Addendum #1

Project Name: Cattle National Bank & Trust - Fallbrook
6550 Merchant Drive
Project No.: 12054
Issued: May 01, 2013
Bid Date: 2:00 pm, CDT May 14, 2013

Revision to Detail **D4/A401**

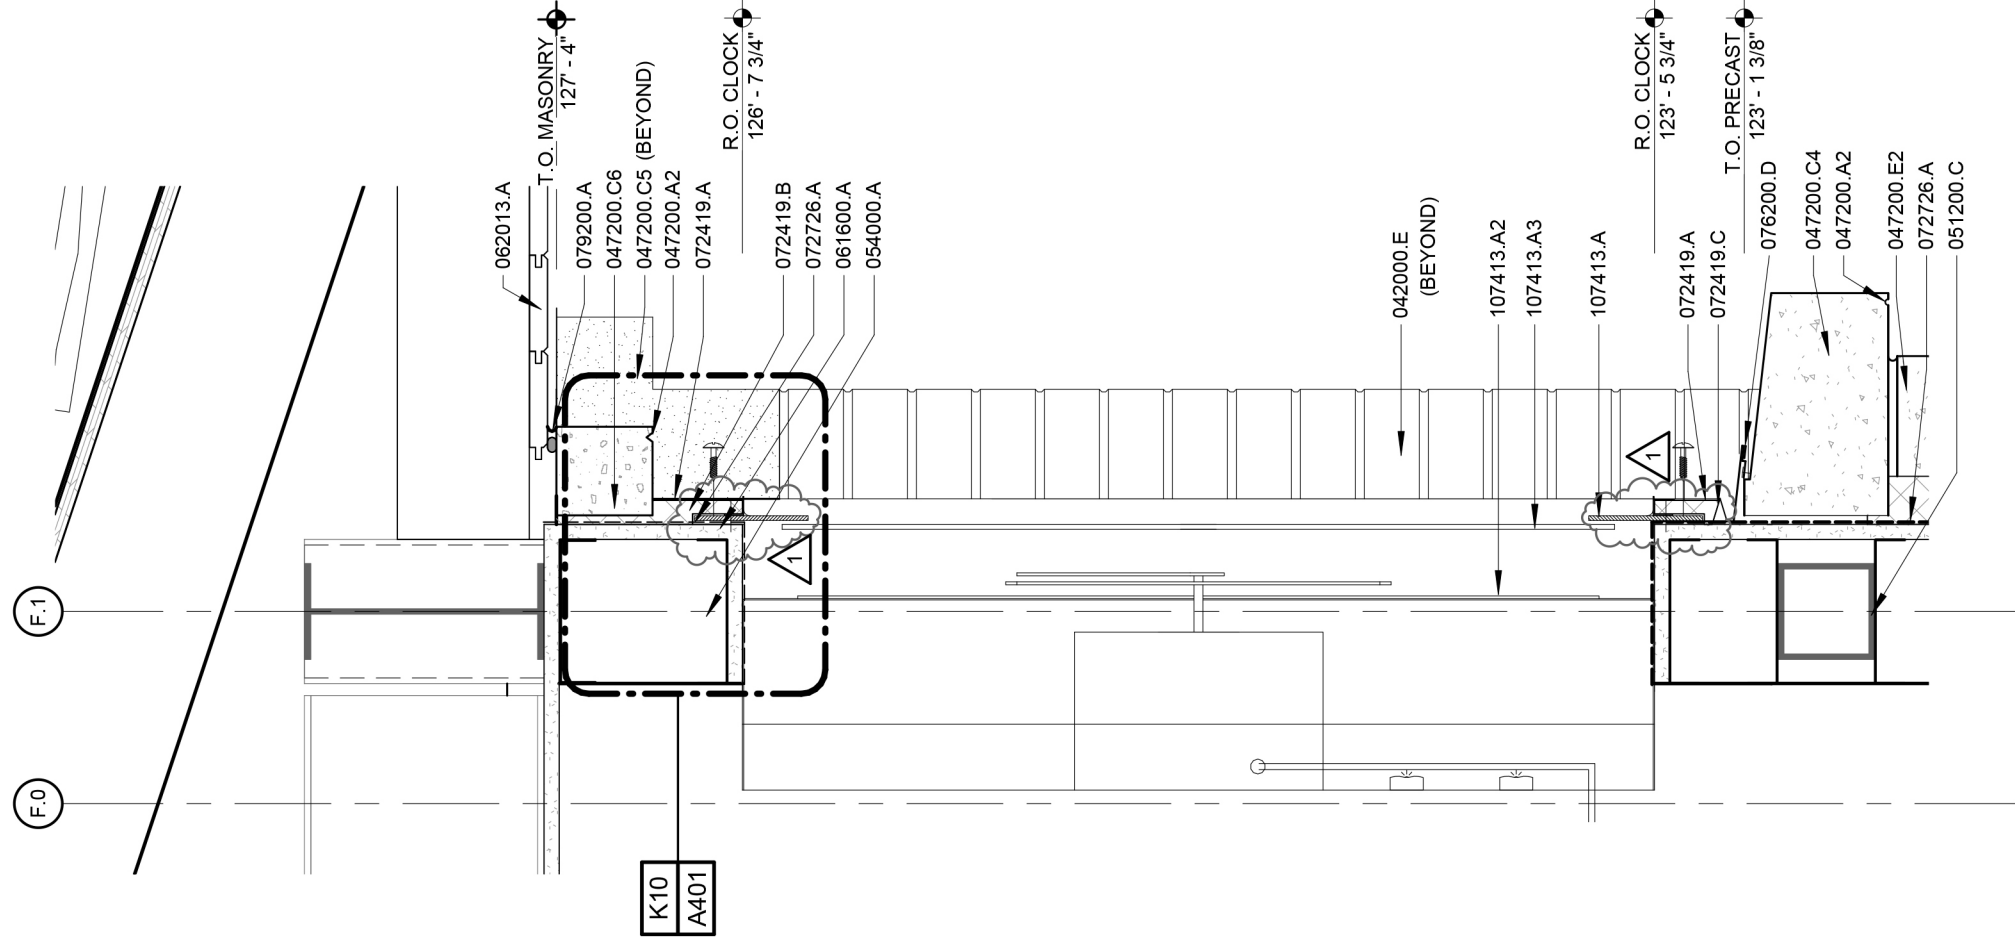
- a. J1/A401: Updated pre-cast at jamb and added note. Refer to Attachment A16.
- b. D4/A401: Updated pre-cast at sill to coordinate with the rough opening elevation of the Teller Window. Revised R.O. Window elevations to be 103'-2 ½" at the bottom of the Teller Window and 106'-3" at the top of the Teller Window. Refer to Attachment A17.

Revision to Detail: **D7/A401**

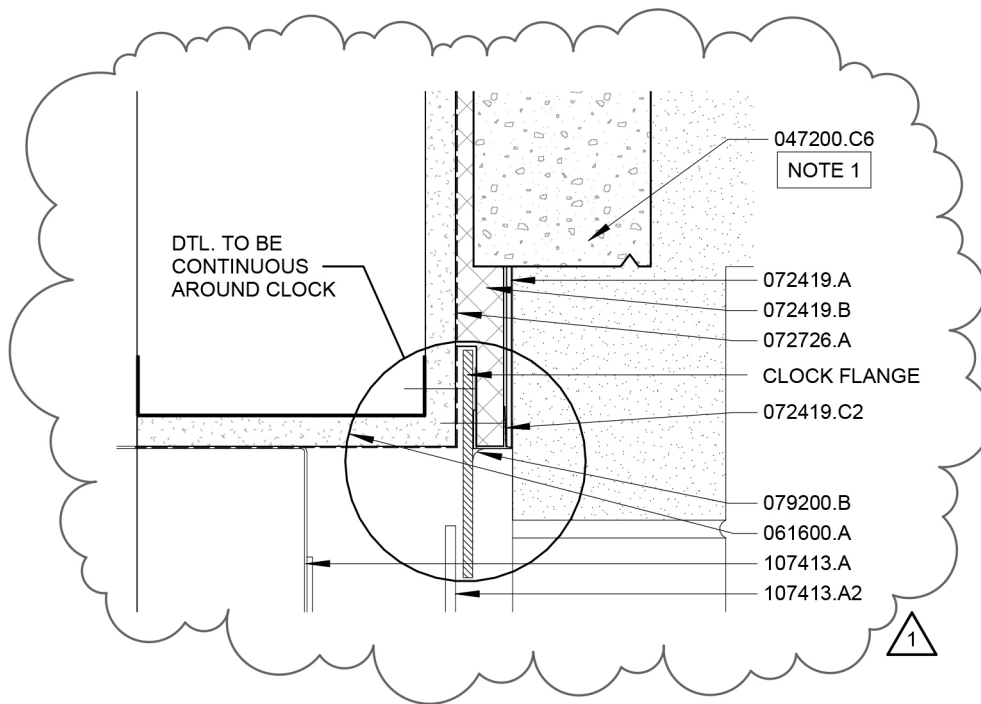
- c. D7/A401: Updated graphic where clock flange meets the EIFS assembly to coordinate with the revised K10/A401 Detail. Refer to Attachment A18.
- d. K10/A401: Updated detail so EIFS Assembly will be notched and overlap the clock flange. Added Keynote 079200.B "Sealant – Refer to Specifications for Sealant Schedule". Added Sheet Specific Note 1 to Cast Stone Belt Course – Style 6 (047200.C6); Sheet Specific Note 1 reads "Precast to be self-supporting. Connect to the cast stone on either side or notch the abutting precast (047200.C5) to allow precast to bear". Refer to Attachment A19.

Revision to Detail **A10/A402**

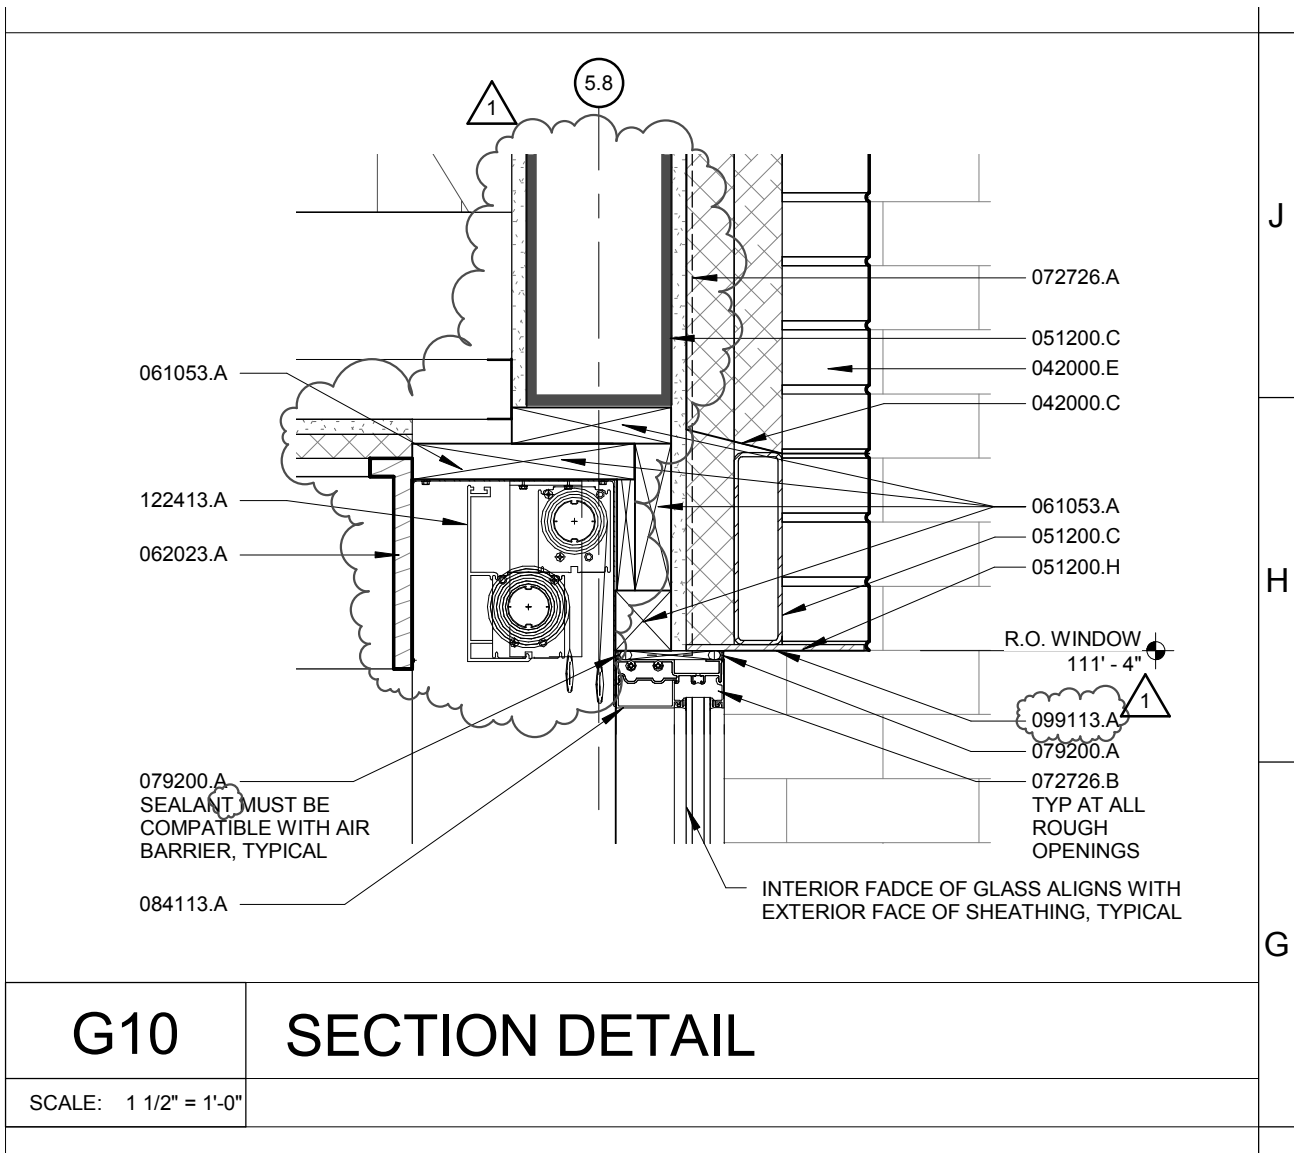
- a. A10/A402: Moved up the Thru-wall flashing assembly, 2-Piece Counterflashing, and Termination Bar one brick coursing and modified tube and plate steel to coordinate with Structural. Added Keynote 051200.C "Steel Tube – Refer to Structural". Refer to Attachment A20.

Revision to Detail **G10/A402**

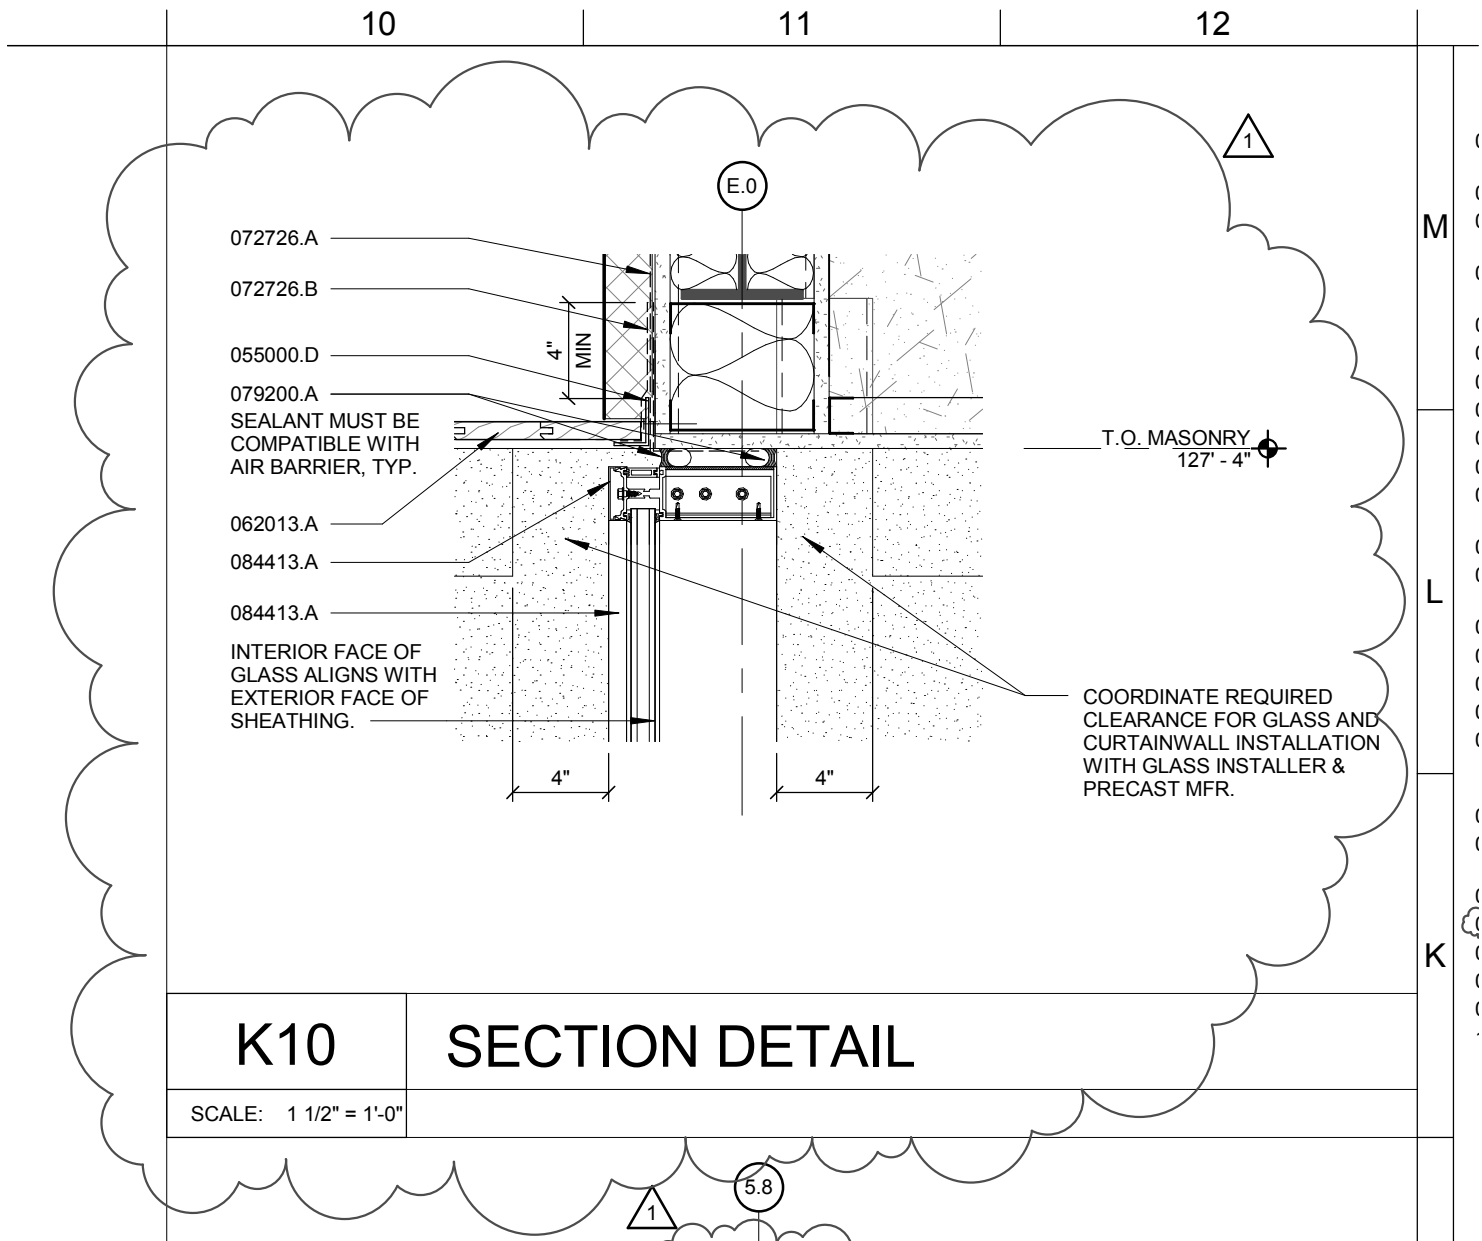
- b. G10/A402: Coordinated drawing with updated structural members, graphically coordinate trim and ceiling and added keynote. Refer to Attachment A21.
- c. K10/A402: Added new drawing of detail at Curtain Wall head. Refer to Attachment A22.

A7

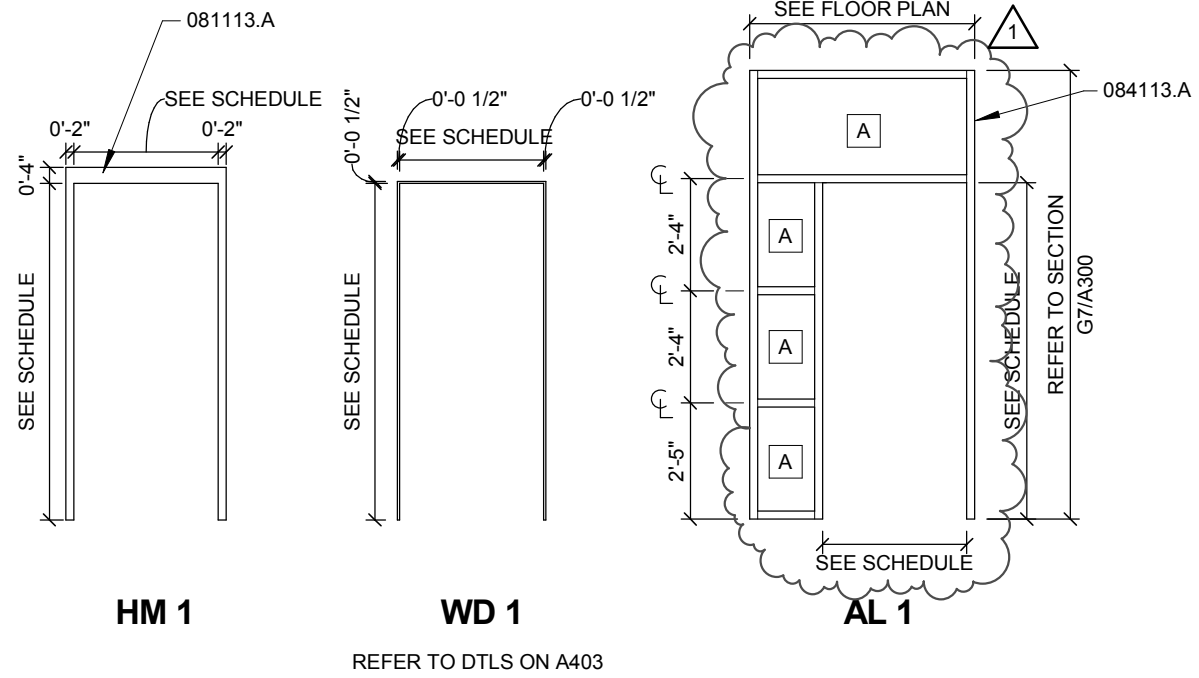
- a. A7/A500: Glass types were incorrect on drawings, updated. Refer to Attachment A23.
- b. H1/A500: Added dimensions to Belt Course Style 3 and modified note. Modified height dimensions of Sill Style 4 (047200.B4); overall cast stone profile height to be 3 1/16". Refer to Attachment A24.
